Bulletin No. 2003-11

MCM Rear Engine Mount Design Change

Original design

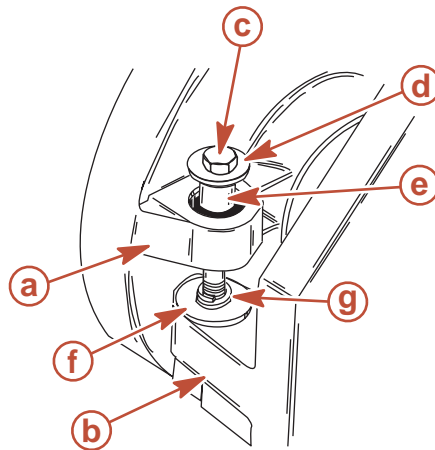
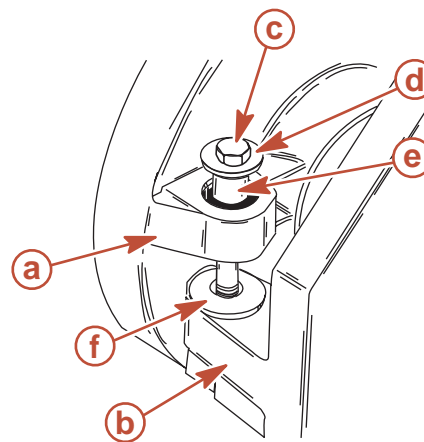
Starting with serial number 0M660000 and above, the rear engine mounts have been redesigned to improve engine alignment between the transom and the engine. With this design, the double wound lock washer has been removed and the flywheel housing engine mount has been adjusted to better align the engine coupler to the gimbal bearing.

- a** - Rear engine mount
- b** - Inner transom plate
- c** - Bolt
- d** - Washer

- e** - Spacer
- f** - Fiber washer
- g** - Double-wound washer

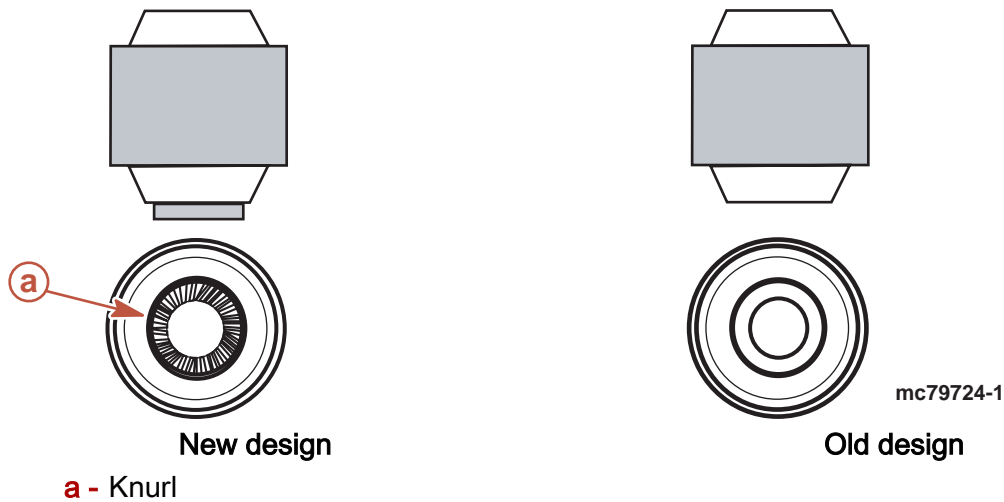
The new flywheel housing mount is serrated on the bottom side where it makes contact with the support mount ear on the inner transom plate assembly. The knurl will prevent mount windup when tightening the rear mount bolt to the nut in the inner transom plate.

mc79566-1

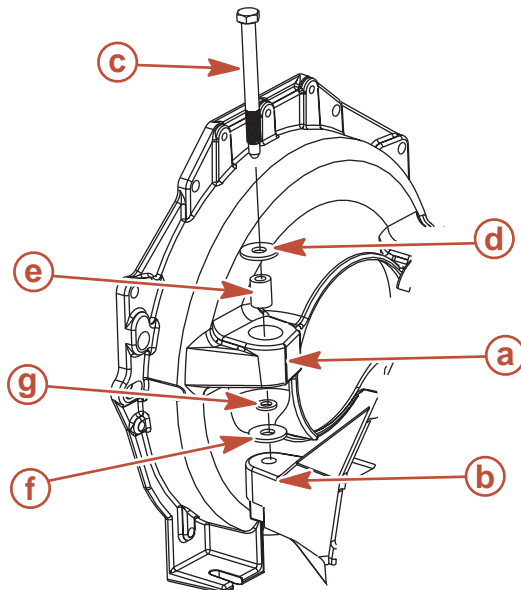
1. Apply glue to the fiber washer and position it equally around the rear engine mount bolt hole on the inner transom plate mount.

2. Place the stainless steel washer inside the fiber washer.
